**LEGAL ADVERTISEMENT
PORTLAND PLANNING BOARD MEETING**

AGENDA
PORTLAND PLANNING BOARD

To: Stuart O'Brien, Chair and Members of the Portland Planning Board
From: Shukria Wiar, Planner
Date: Thursday, July 12, 2014
Re: Text Amendment; 899 Riverside Street; City of Portland
Project #: 2012-108 CBL: 326 B004002
Meeting Date: July 22, 2014

SHEET C7.1

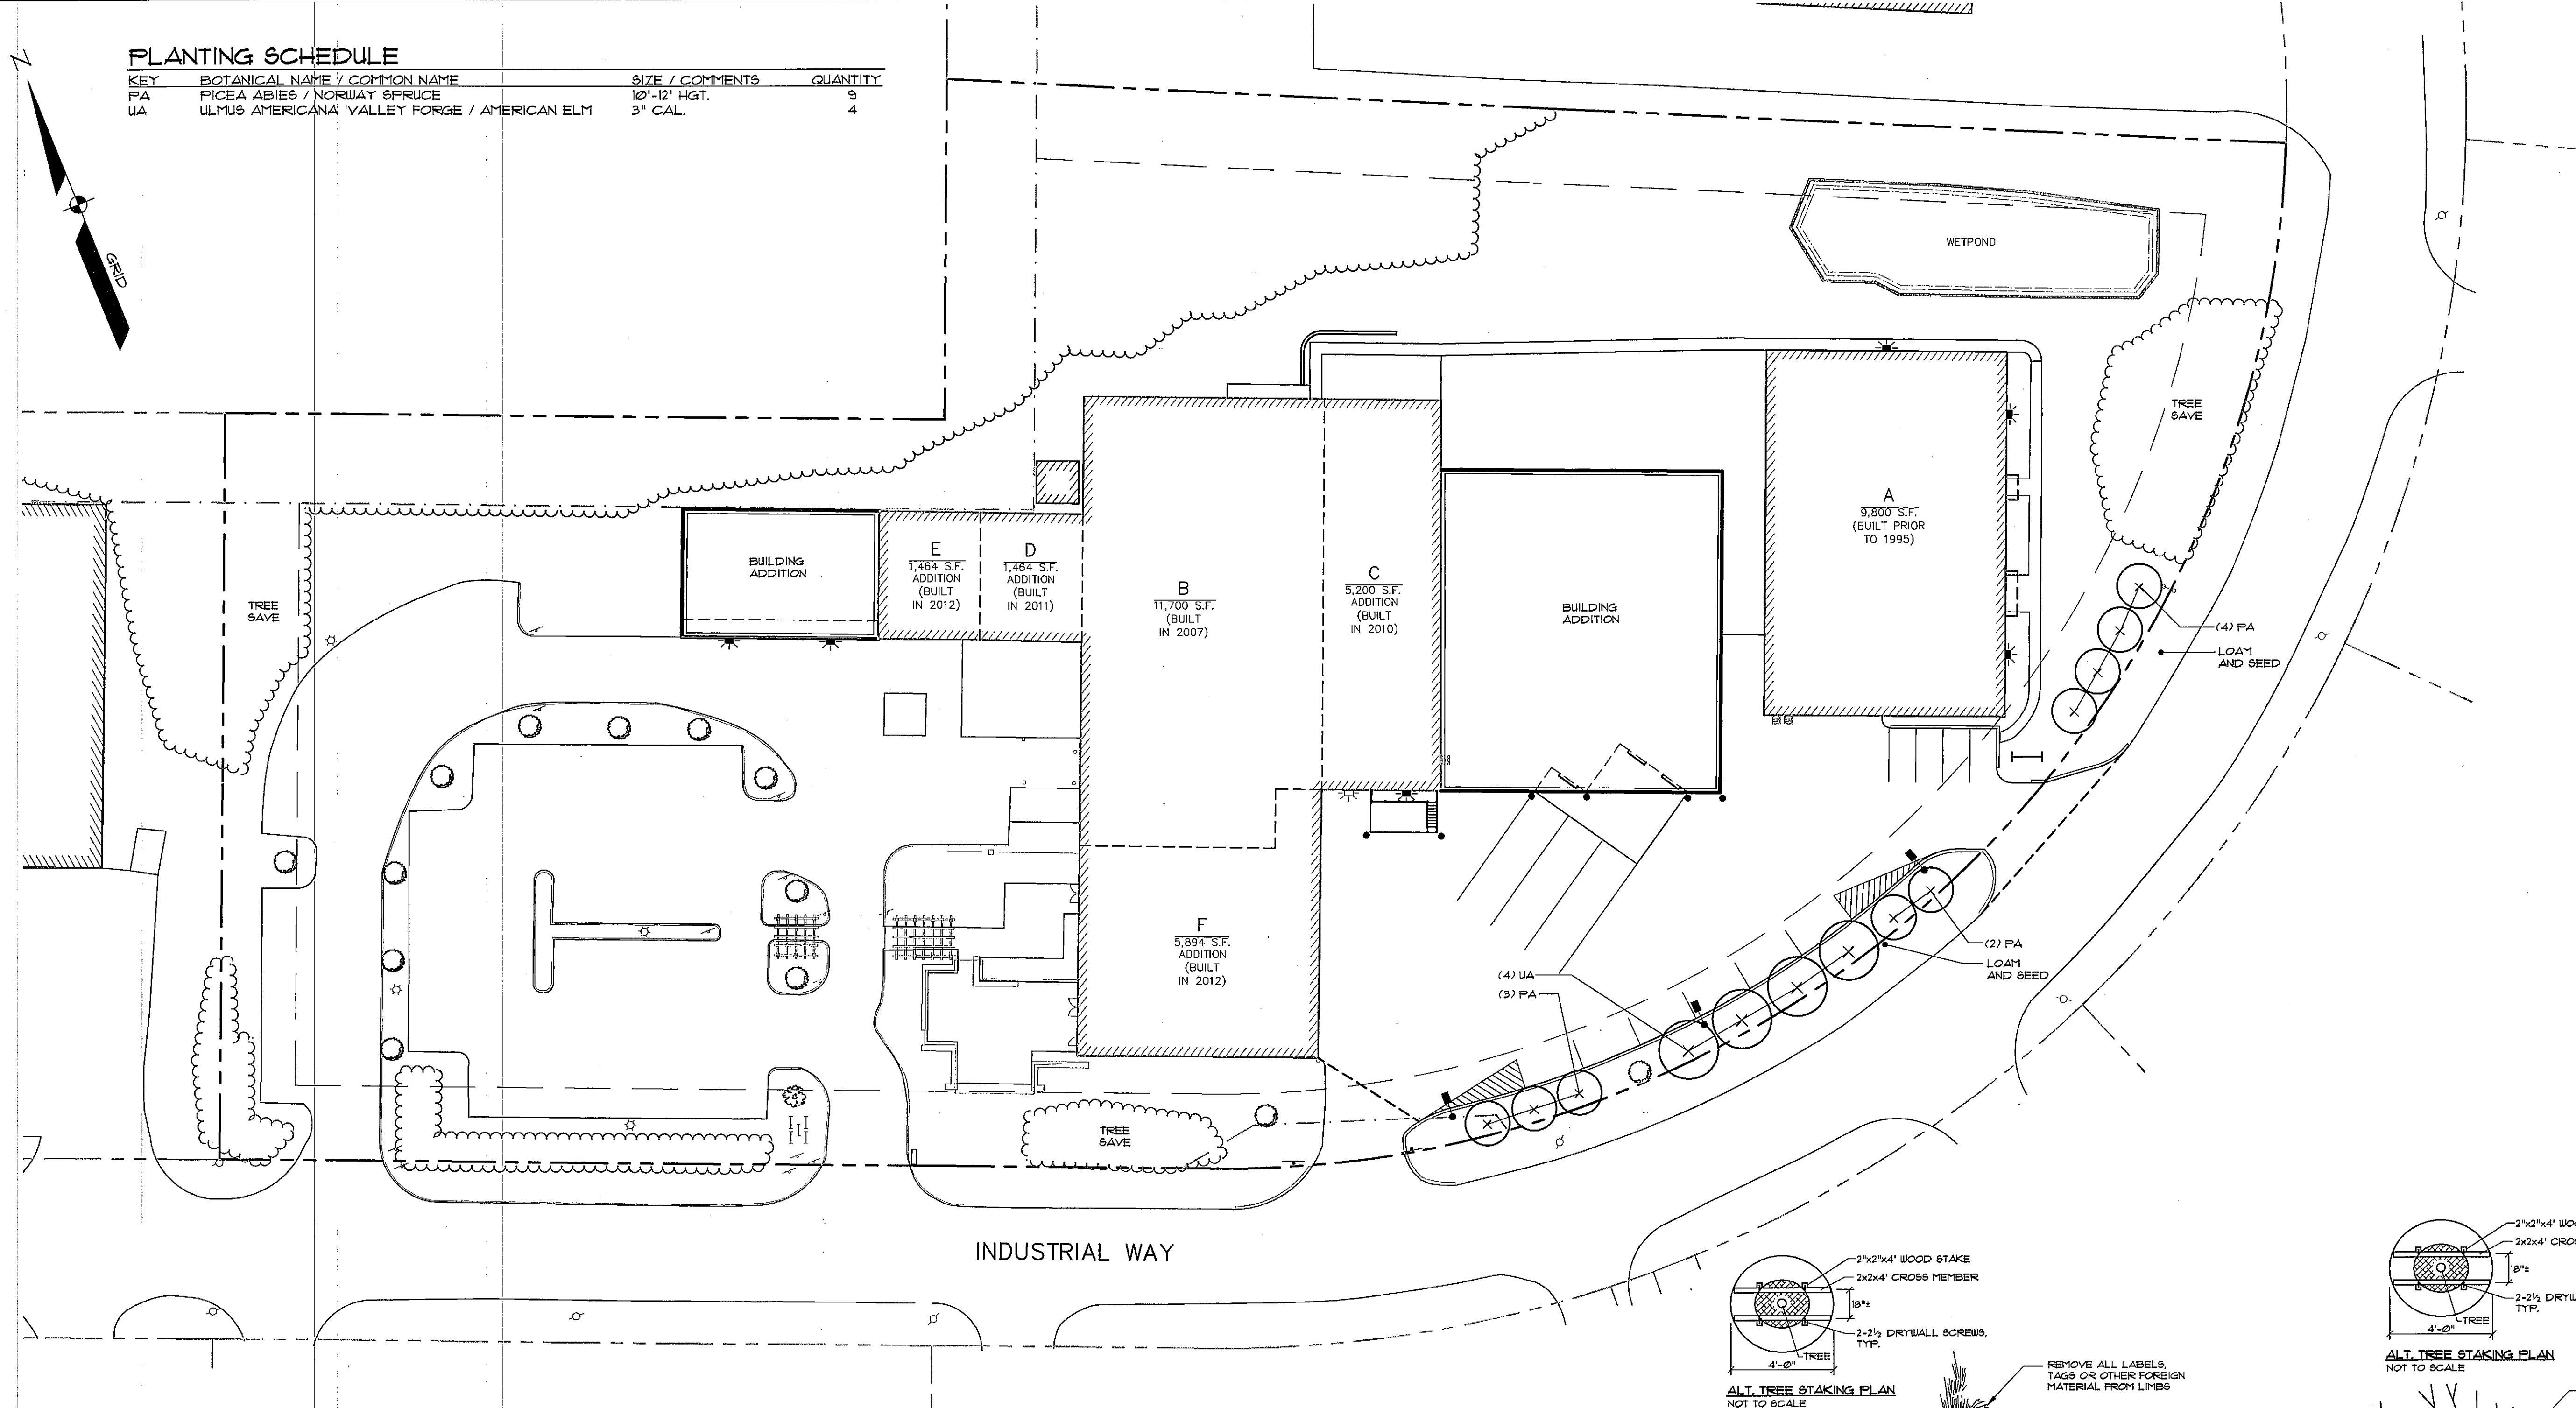
Sheet C7.2 – The Landscape Plan for Phase 2 shows trees within the drainage way and inslope for the detention pond (along the north edge of the site). This landscape plan should be coordinated with the grading plan, and notes should be added to ensure the grading work doesn't impact the installation of the landscaping (and vice versa).

- 3) Sheet C7.2 – The Landscape Plan for Phase 2 shows trees within the drainage way and inslope for the detention pond (along the north edge of the site). This landscape plan should be coordinated with the grading plan, and notes should be added to ensure the grading work doesn't impact the installation of the landscaping (and vice versa).
